**As-Built Baseline Monitoring Report**

**CATBIRD SITE**

NCDMS Project #100022 (Contract #7186)

RE: Catbird Site: Baseline Report and As-Built Drawings (NCDMS ID 100022)

DRAWING TITLE:  
PLANTING PLAN

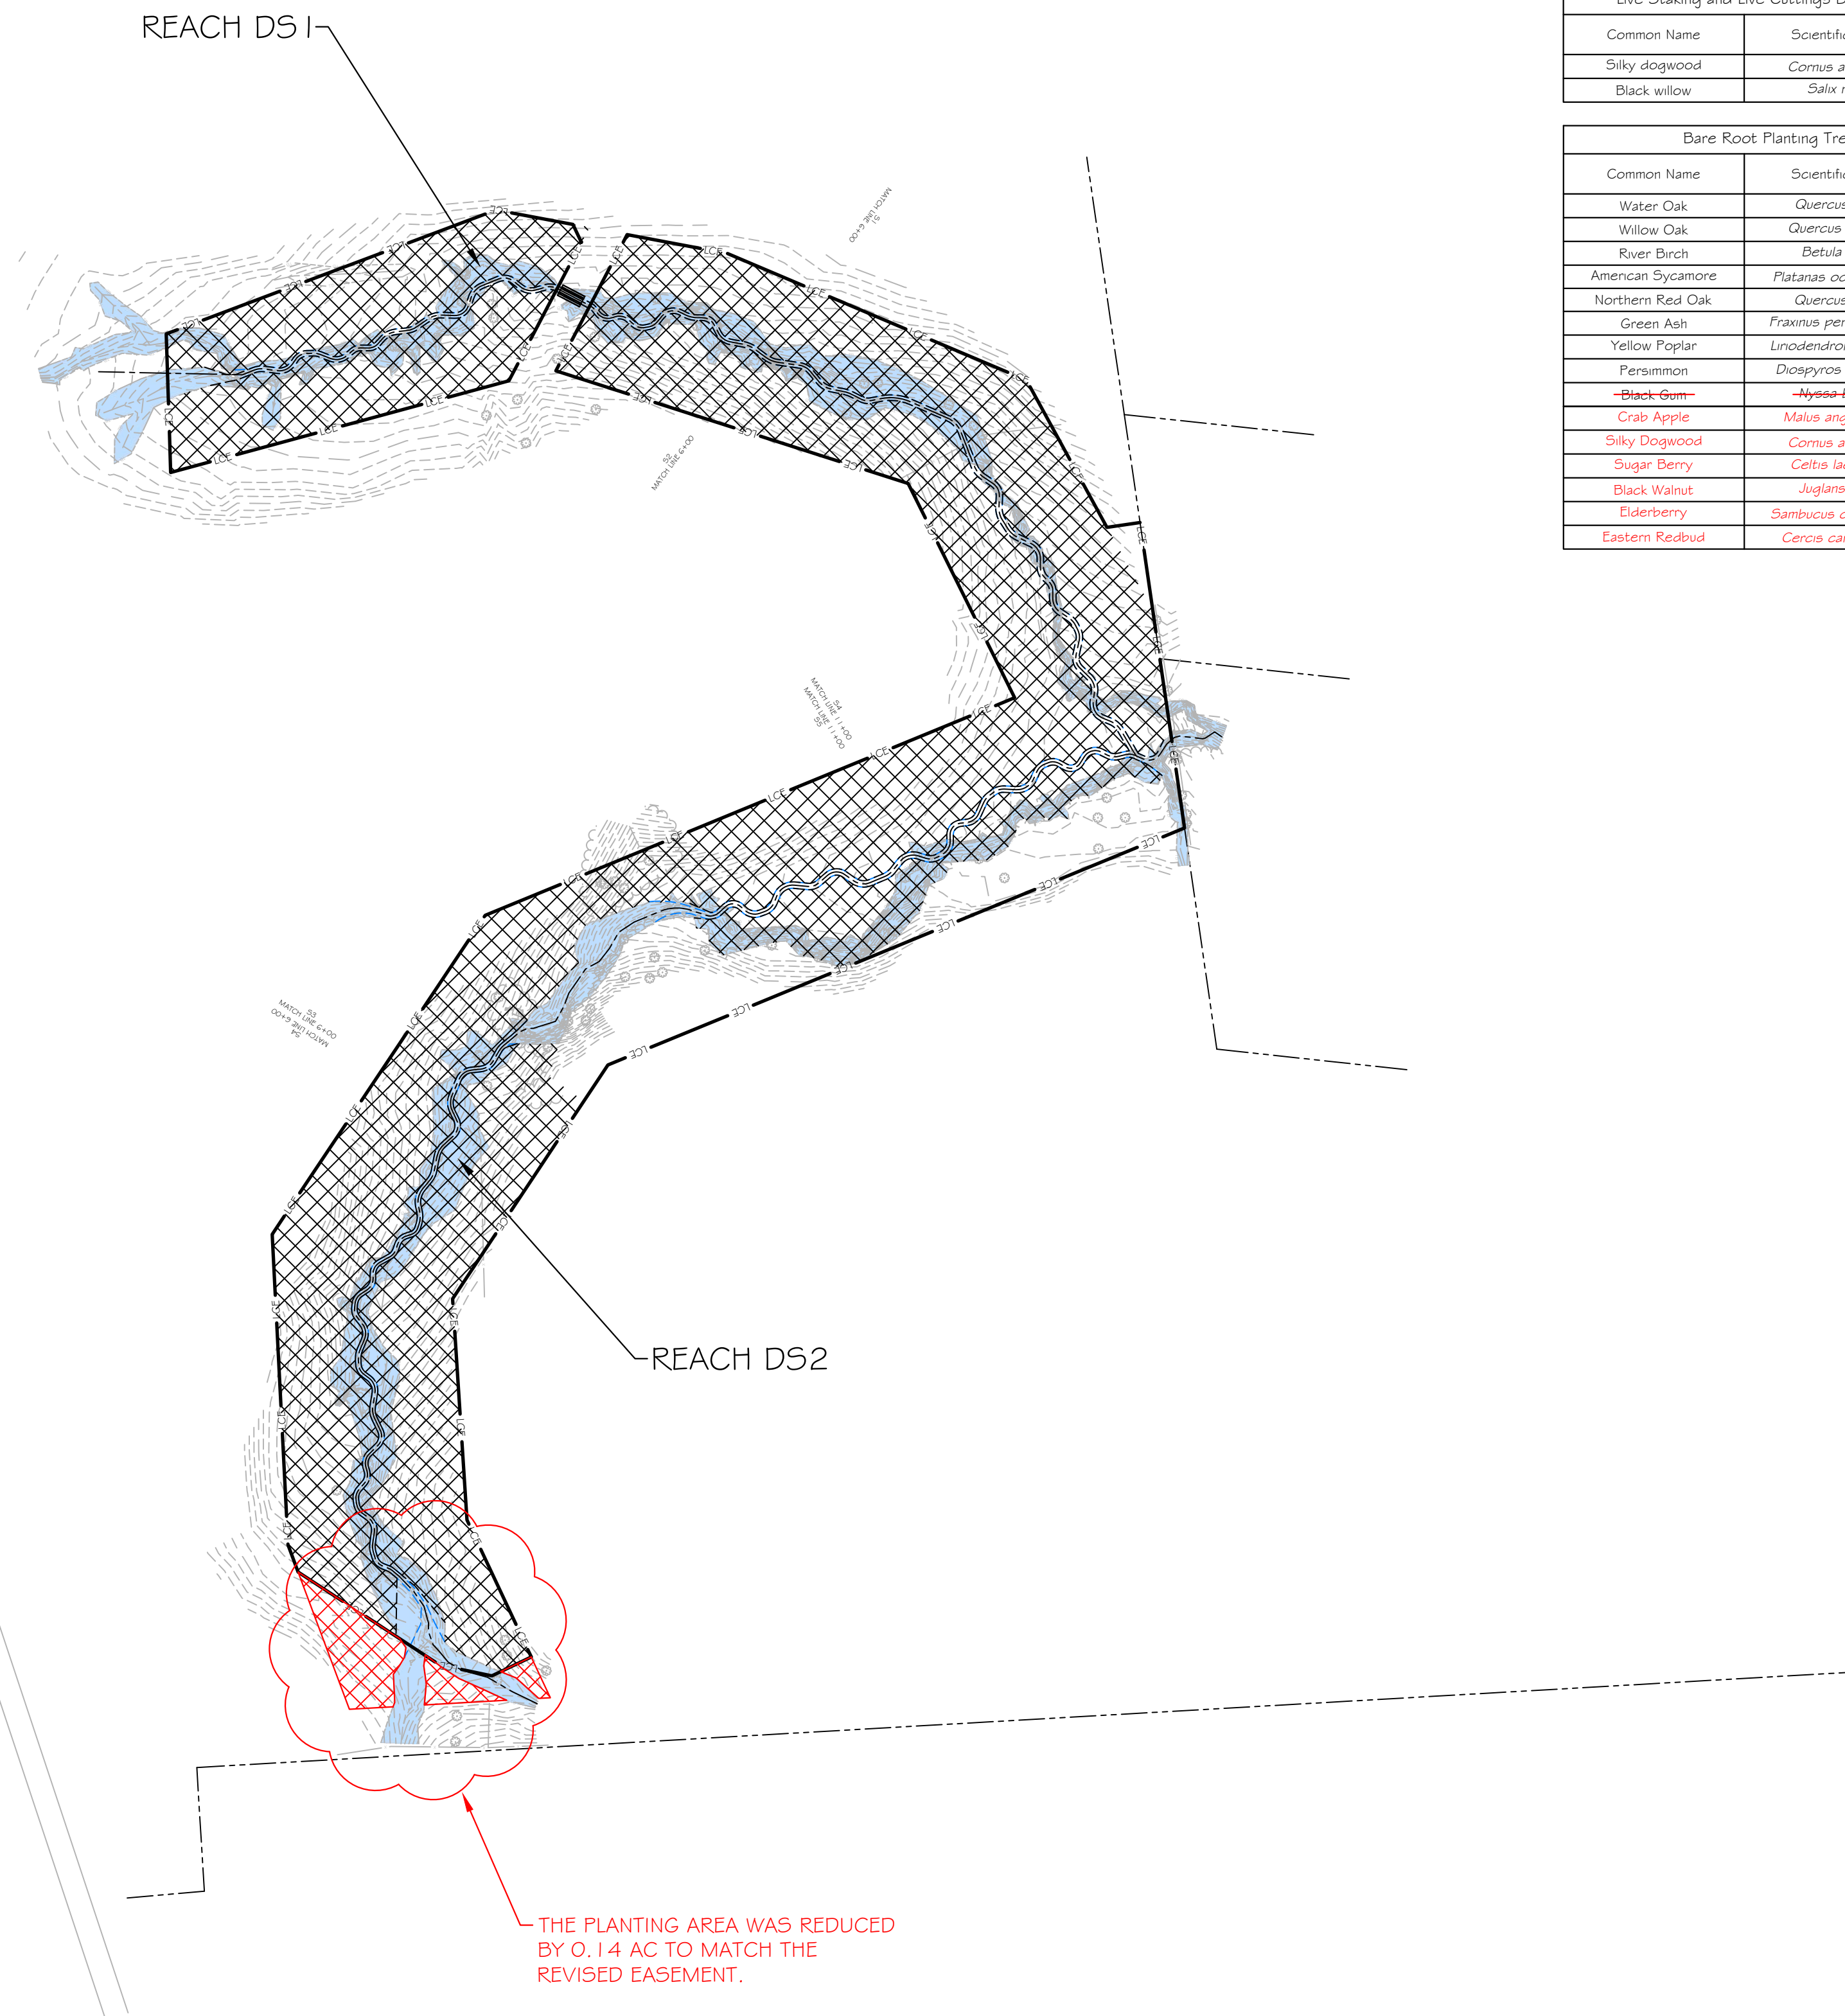
Record Drawings need to include the planting plan from the mitigation plan (sheet P1), to make clear the actual planting zones with stem counts and species and if/how any changes were made from the mitigation plan (shown in red).

[Done.](#)

## Easement Comparison Map

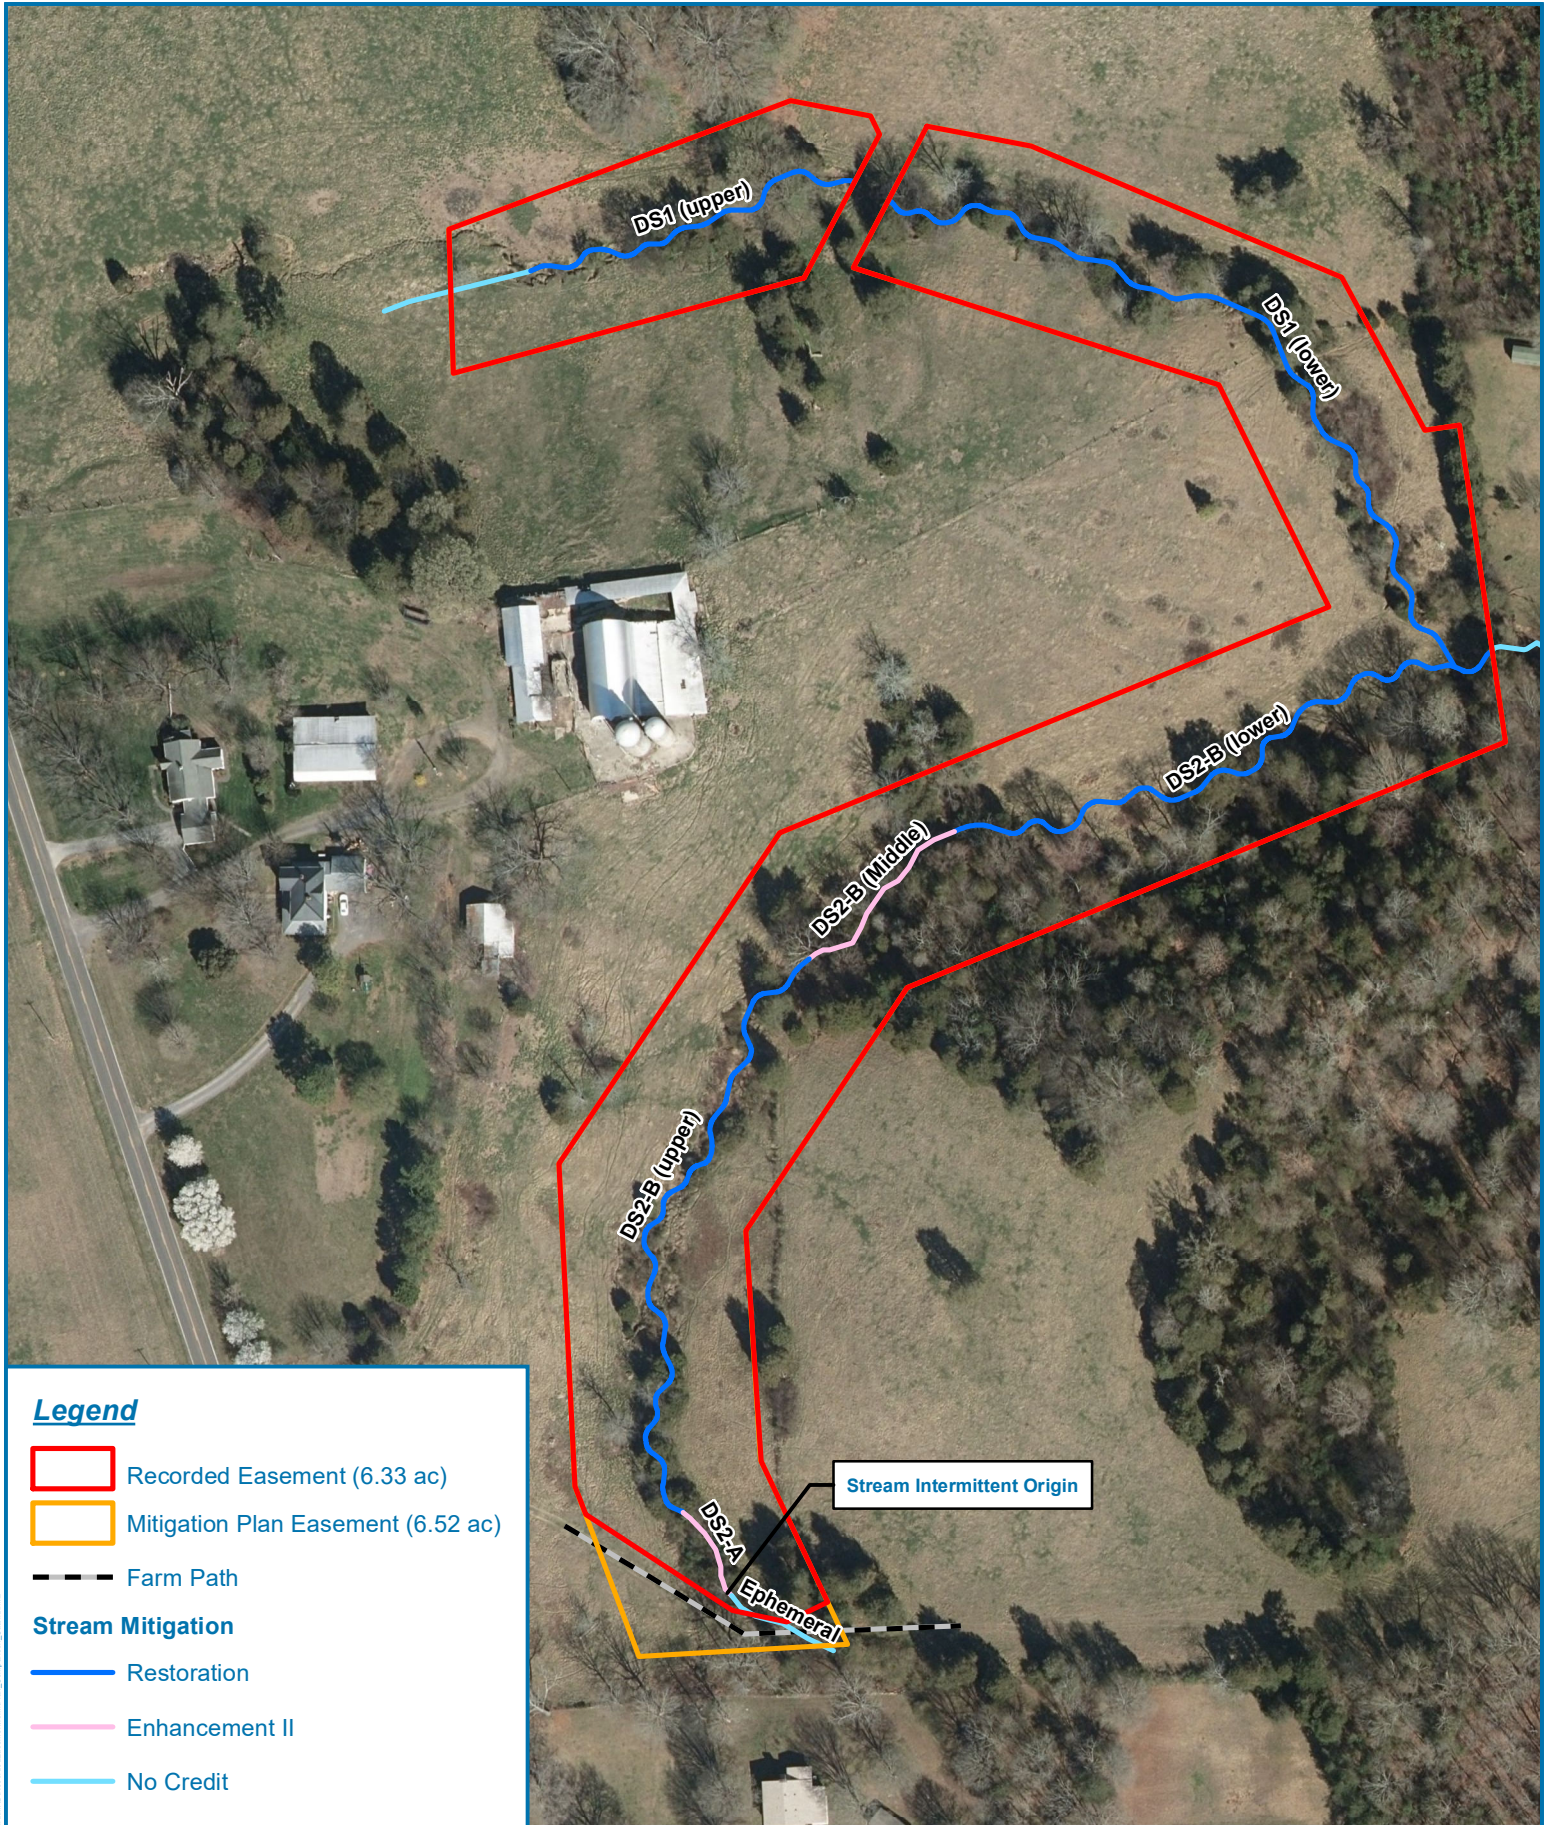
Uncredited reach is shown as white against a white background in the legend. Please use a color/pattern that is visible.

Please modify figure and report tables as discussed, to reflect accurate crediting and discussion of easement adjustment vs. mitigation plan, at upper limit of DS2-A. Please provide the resulting final digital support files for review.

[Done.](#)

[Done.](#)
